AMENDMENTS TO THE DRAWINGS

REMARKS

Fig. 2

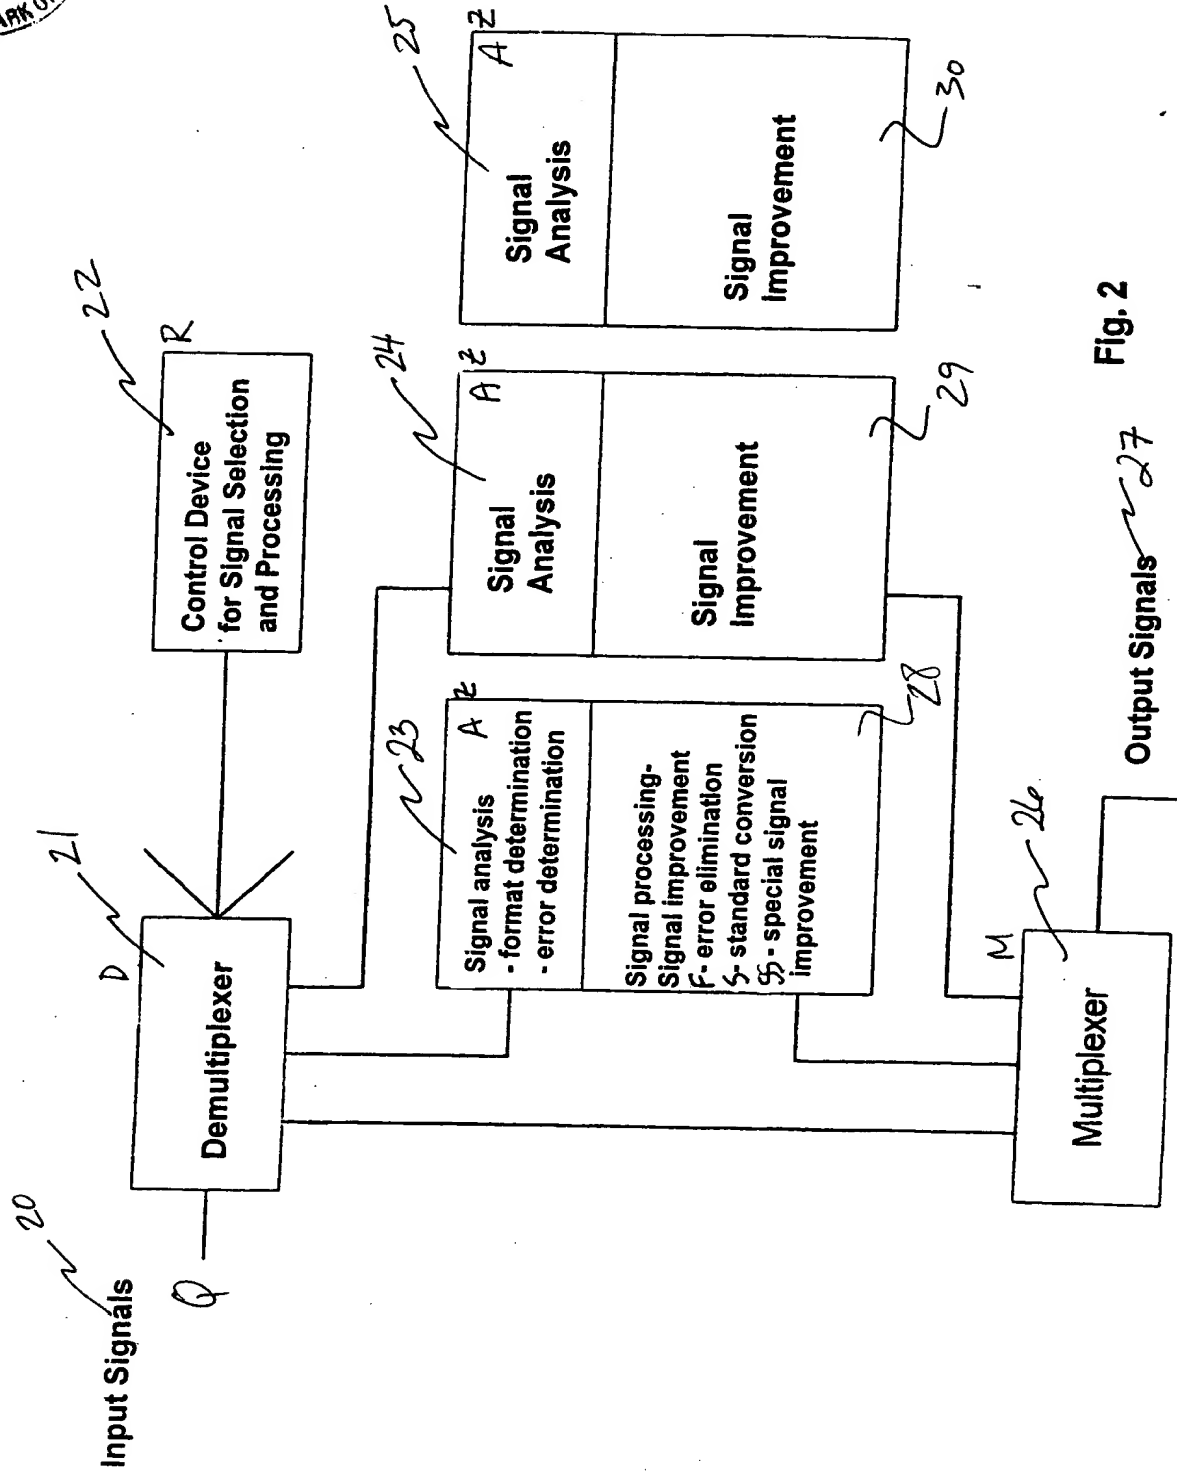
The attached two sheets of drawings includes changes to Figs. 1 and 2. The [REPLACEMENT] sheet of Fig. 1 replaces the original Fig. 1 sheet; the [REPLACEMENT] sheet of Fig. 2 replaces the original Fig. 2 sheet. Figs. 1 and 2 are amended to include reference numbers.

Figs. 1 and 2 were rejected for not having reference numerals. In accordance with the Examiner's request, Applicants have amended Figs. 1 and 2 to have reference numbers and have submitted herewith those Figs. for acceptance by the Patent Office. Accordingly, Applicants respectfully submit that the Figs. 1 and 2 are now allowable; and, withdrawal of the objections is respectfully requested.

The Specification was amended to include reference numbers in the description corresponding to the amended Figs. 1 and 2. No new matter has been added.
